Committee of Experts on the Transport of Dangerous Goods and on the Globally Harmonized System of Classification and Labelling of Chemicals

Sub-Committee of Experts on the Transport of Dangerous Goods

Comments on ST/SG/AC.10/C.3/2014/101 – Consideration of what constitutes “Equipment”

**Transmitted by PRBA – The Rechargeable Battery Association and
RECHARGE, the European Association for Advanced Rechargeable
Batteries**

EXHIBIT 3 - INTERIOR WITH BATTERY

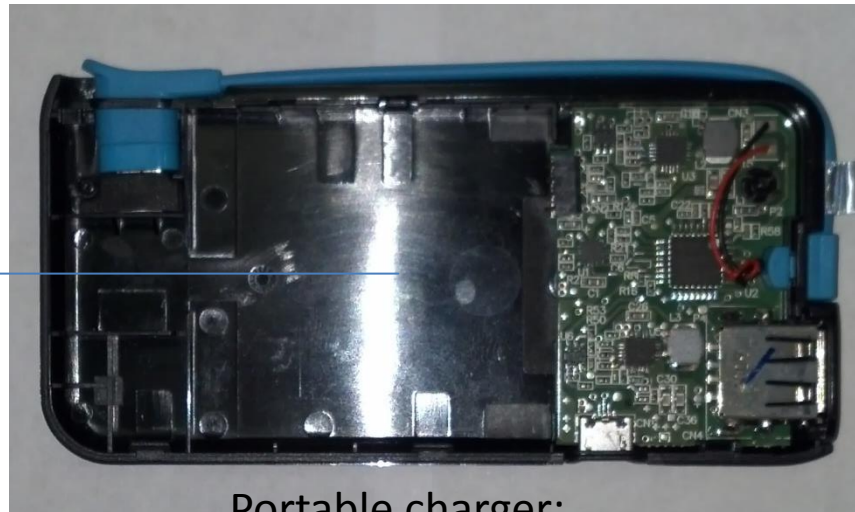
4. To be classified as lithium ion batteries, power packs would need to be tested in accordance with the UN Manual of Tests and Criteria. Power packs are generally not subjected to the UN testing scheme. Instead, the cell or battery inside the power pack is submitted separately for testing and then incorporated into the power pack after testing is completed. A picture of a stand-alone battery that has been subjected to UN testing and designed to power a power pack is shown in EXHIBITS 3 and 4 on pages 4 and 5.

EXHIBIT 4 - COMPARISON WITH

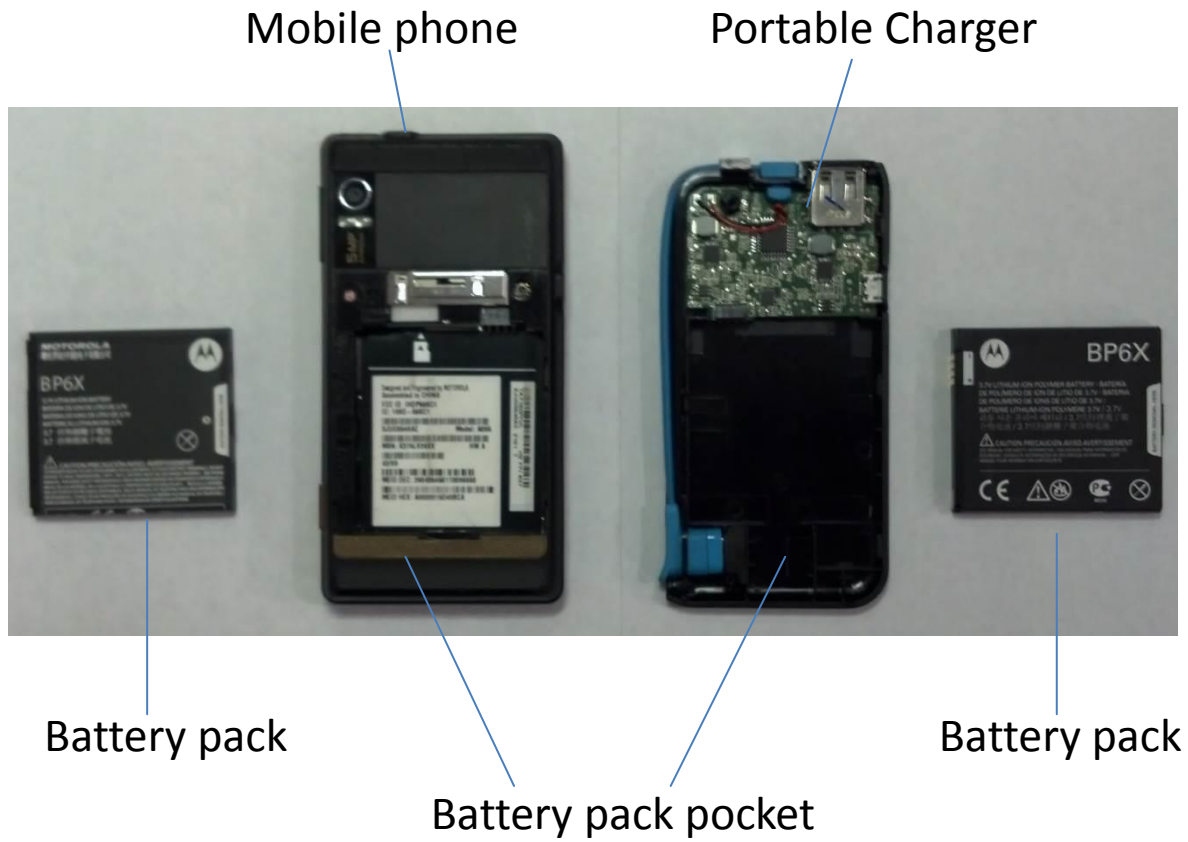
3. Power packs are often comprised of batteries, plus charge-in/charge-out regulator circuit, connectors, fuel gauge, etc. In some cases the batteries contained in power packs also are used in other host articles such as cellular phones. (See EXHIBIT 4 on page 5.) Power packs also are generally shipped as consumer retail items that include a retail box with manual and accessories. Pictures of these various articles associated with power packs are shown in EXHIBIT 5 on page 6.
